UNITED STATES PATENT AND TRADEMARK OFFICE

APPLICATION NO.	FILING DATE	FIRST NAMED INVENTOR	ATTORNEY DOCKET NO.	CONFIRMATION NO.
10/804,022	03/19/2004	Tomoko Taguchi	008312-0308844	8904

Office Action Summary

Detailed Action

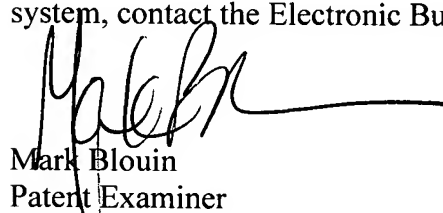
10. Regarding Claims 4 and 9, Sato et al shows (Figs. 1-3) the magnetic disc apparatus, wherein the write shield (13+35+34) has a shape such that a number of stacks of the magnetic layer (35) and the nonmagnetic layer (34) are larger in each of the edge portions than those in a central portion (thinner portion located above pole tip (24)) along the track width direction (see Examiner's Drawing).

FIG. 1

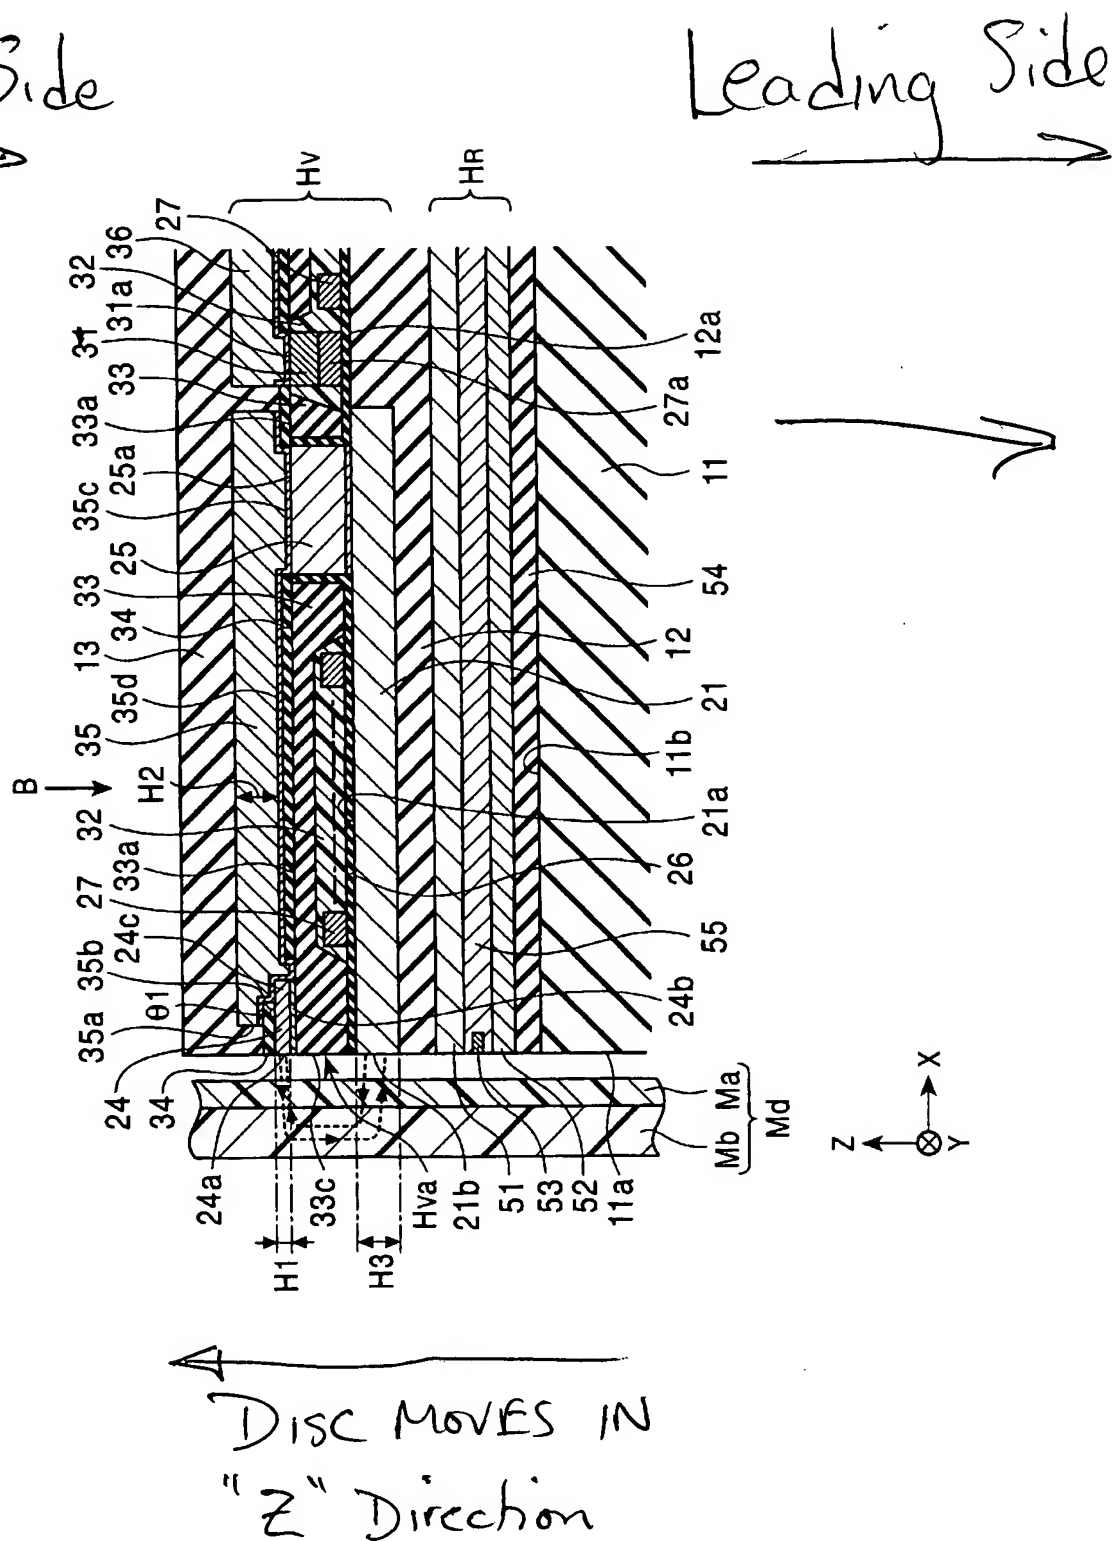
8. Claims 3-5 and 8-10 are rejected under 35 U.S.C. 102(e) as being anticipated by Sato et al (US 6,697,221).
9. Regarding Claims 3 and 8, Sato et al shows (Figs. 1-3) a perpendicular magnetic recording head, comprising: a double layered perpendicular recording medium (Md) comprising a soft magnetic underlayer (Mb) and a perpendicular recording layer, which are formed on a substrate (Ma); and a perpendicular magnetic recording head comprising a main pole (24) configured to generate a recording magnetic field in a perpendicular direction, and an auxiliary pole (21) connected to the main pole on a leading side to the main pole (see Examiner's Drawing- connected through portion 25 – highlighted area), and a write shield (13+35+34) arranged apart from the main pole on a trailing side to the main pole and having a multilayered structure in which a nonmagnetic layer (34) is sandwiched between magnetic layers (35 and 24 – see Figure 2).

11. Regarding Claims 5 and 10, Sato et al shows (Figs. 1-3) the magnetic disc apparatus, wherein the auxiliary pole (21,21a)) has a multilayered structure in which a nonmagnetic layer (26) is sandwiched between magnetic layers (Col 8, lines 21-25).
